## RECOMMENDATION REPORT

### Australian War Memorial Redevelopment, Campbell, ACT (EPBC 2019/8574)

Figure 1:  
Hollow bearing  
tree to be  
removed (in  
red box)

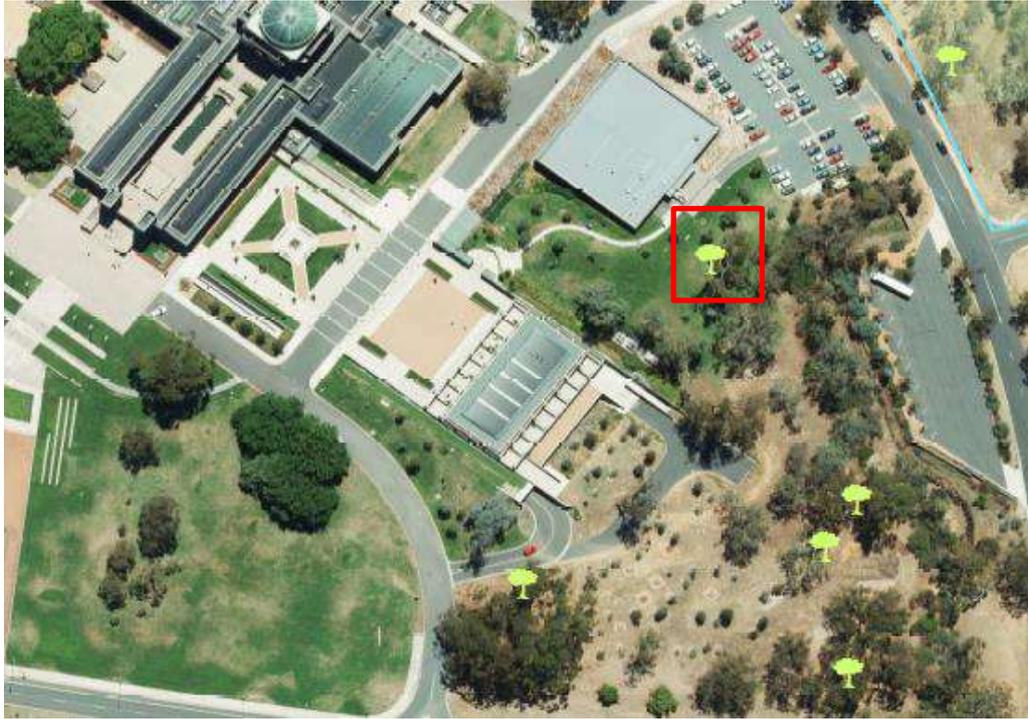
<ul style="list-style-type: none"> <li>a. Protect all onsite mature trees that are not planned for removal (i.e. exclusion fencing).</li> <li>b. Clear only one hollow bearing tree in accordance with Figure 1.</li> <li>c. Prevent soil erosion and stormwater contamination and implement contingency measures in the event of an impact being detected.</li> <li>d. Monitor and manage any underground storage tanks to prevent soil and groundwater contamination.</li> <li>e. Prevent any <b>impacts</b> to known Aboriginal Cultural Heritage sites in accordance with Figure 2.</li> <li>f. Quickly detect any previously unknown items of Aboriginal Cultural Heritage that are encountered during <b>construction</b>, immediately stop any works that could cause <b>impacts</b> until consultation with Registered Aboriginal Organisations results in agreement to resume works.</li> <li>g. Induct <b>construction</b> personnel so that they are aware of the National and Commonwealth Heritage values and the Aboriginal Cultural heritage values of the site.</li> </ul> <p>These measures must be established prior to the <b>commencement of the action</b> and maintained throughout the duration of <b>construction</b> activities.</p>

Figure 3:  
Parade Ground  
design changes  
– removed  
areas in red,  
added areas in  
green

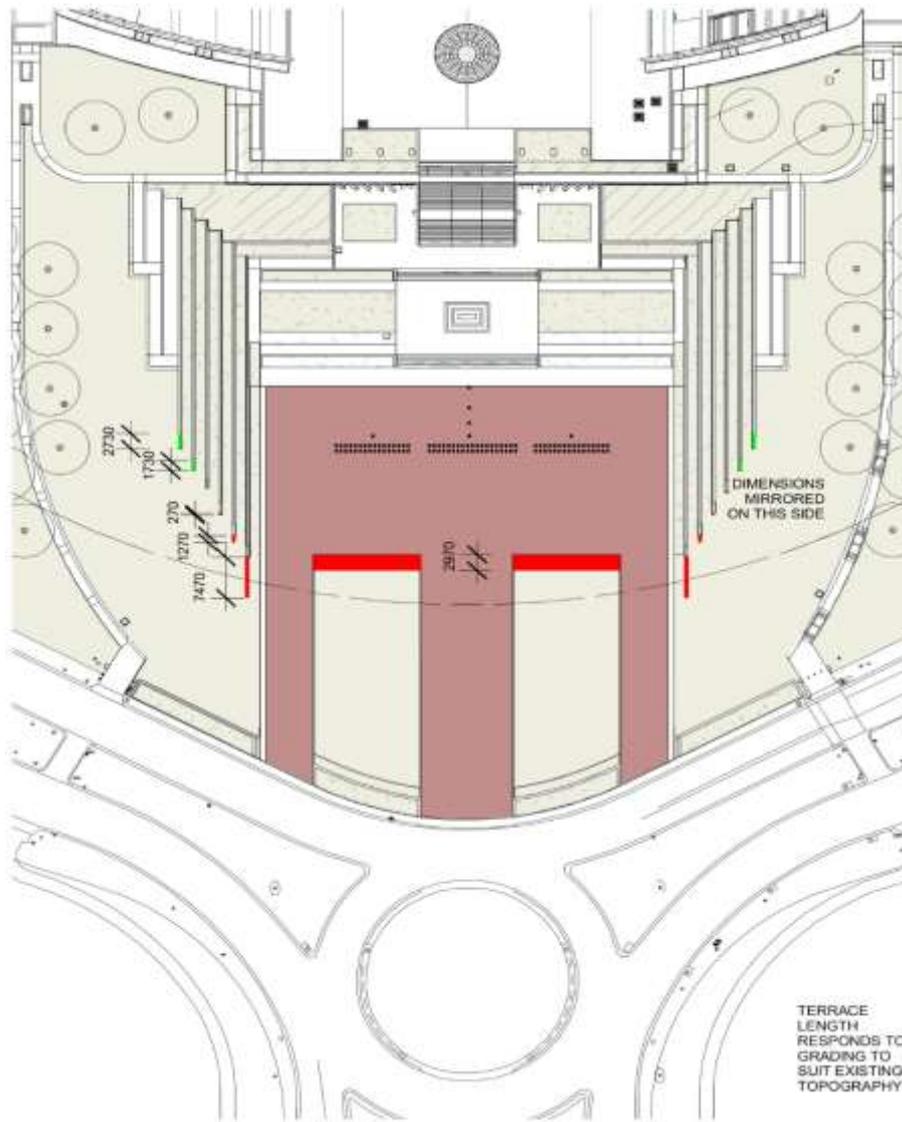
84. The proposed Parade Ground layout has been changed in response to public comments around the length of sandstone terraces and the area of gravel. The dimensions of the gravel area have reduced by 3m in the north/south direction. The area of overall gravel is now near equivalent to the existing gravel area. The length of sandstone terraces has also been reduced. The Department has recommended these changes as condition 18.

**Figure 4:** New Southern Entrance – view of the Oculus to the Dome

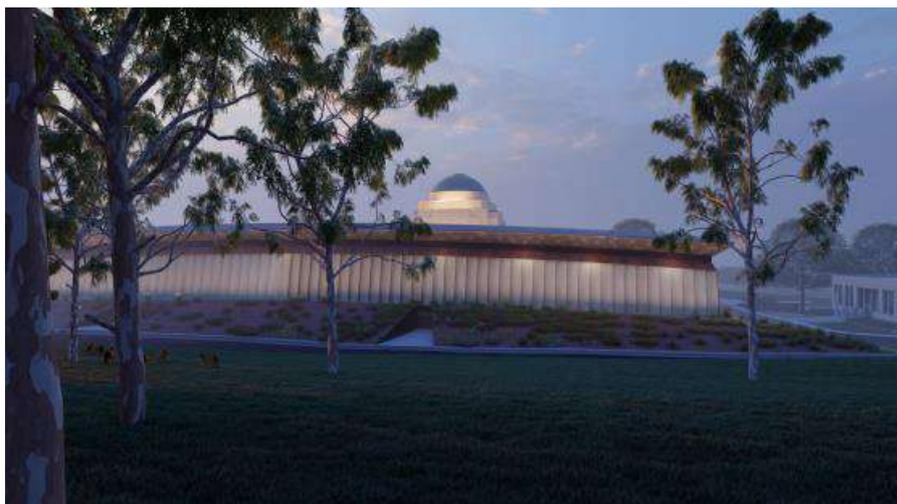
64. The Department's concerns in relation to the need for the oculus as a focal/orientation point and to provide connection between the new and original entrance and proposed changes to reduce the impact are addressed in detail in **Attachment C7**. The impact of

<p>9. To minimise the <b>impacts</b> of the action on <b>protected matters</b> the <b>approval holder</b> must:</p> <p>a. Ensure the Oculus dome is constructed of low reflectivity glass (maximum external reflectivity of 10%).</p> <p>b. Ensure the Oculus dome height does not exceed 400mm above the <b>forecourt</b> ground level.</p> <p>c. Ensure the angled flat bronze handrail surrounding the Oculus does not exceed 750mm in height from <b>forecourt</b> ground level and does not contain glass infill.</p> <p>d. Ensure the surrounding stone kerb is 250mm in height from <b>forecourt</b> ground level (see Page P-32 of <b>Appendix A</b>).</p>	64a, 126b, Table 1, Table 2, Table 8, Table 9
<p>10. To minimise the <b>impacts</b> of the action on <b>protected matters</b> the <b>approval holder</b> must:</p> <p>a. Ensure that the external glass lift is constructed of low reflectivity glass (maximum external reflectivity of 13%) with a frameless glass facade as shown on pages P-20 and P-23 of <b>Appendix A</b>.</p>	62, 126b, Table 1, Table 2, Table 8, Table 9

**Figure 13:**  
Proposed change in shape of the Parade Ground (original to the left and proposed to the right)

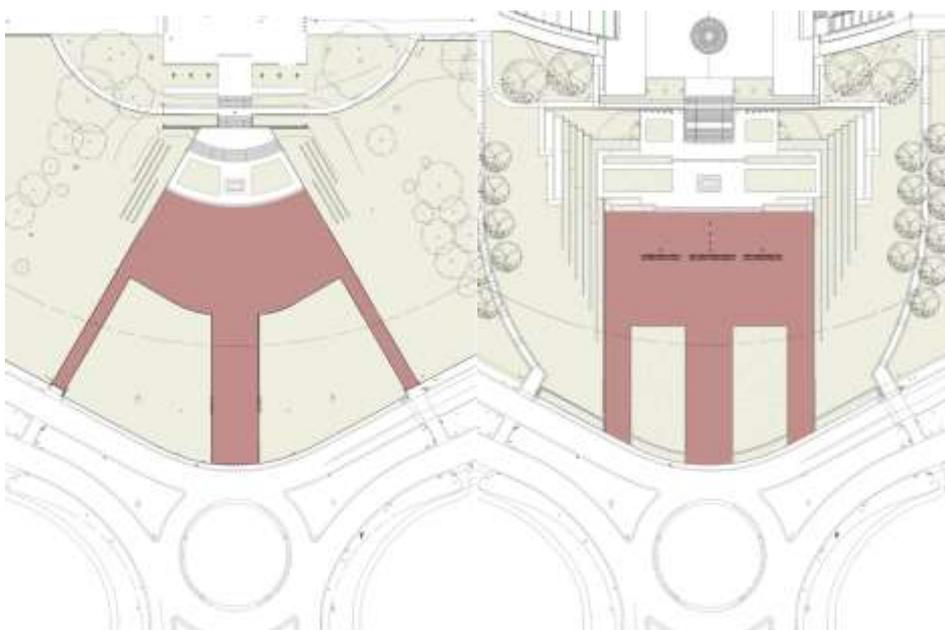
20. The Parade Ground will be re-shaped to return it to its original rectangular shape. The current splayed sides will be made parallel to Anzac Parade. The existing grass bank on the northern side, supporting the entrance terrace, will be made into a building façade, partly embedded in sloping grass at each end. Terrace seating will be improved for accessibility for visitors in wheelchairs. The existing stairs from the Parade Ground will be reconstructed in sandstone at a constant width. See Figure 13 for proposed change to Parade Ground shape and **Attachments C6 and C10** for Parade Ground and Public Realm renders.

The PD and HIA do not provide an assessment of the combined impacts of the proposed action on the landscape setting, including the impact of the Parade Ground.	The Parade Ground changes are proposed to aid military formations and viewing of events and ensures enough space to manoeuvre vehicles. The new sides of the Parade Ground will be aligned to be parallel to Anzac Parade and will return the Parade Ground to the 1941 rectilinear form. In response to public comments, the AWM has committed to reduce gravel area of the Parade Ground by 3 metres in the north/south direction and the length of the terraced seating, so that the area of gravel is now near equivalent to the existing gravel area.	The Department has recommended this amended design as condition 18 and condition 14 for the AWM to notify the Department and provide evidence that final Parade Ground layout design has been supported by the NCA. Given the proposed mitigation measures and recommended conditions, the Department considers this issue has been sufficiently addressed.
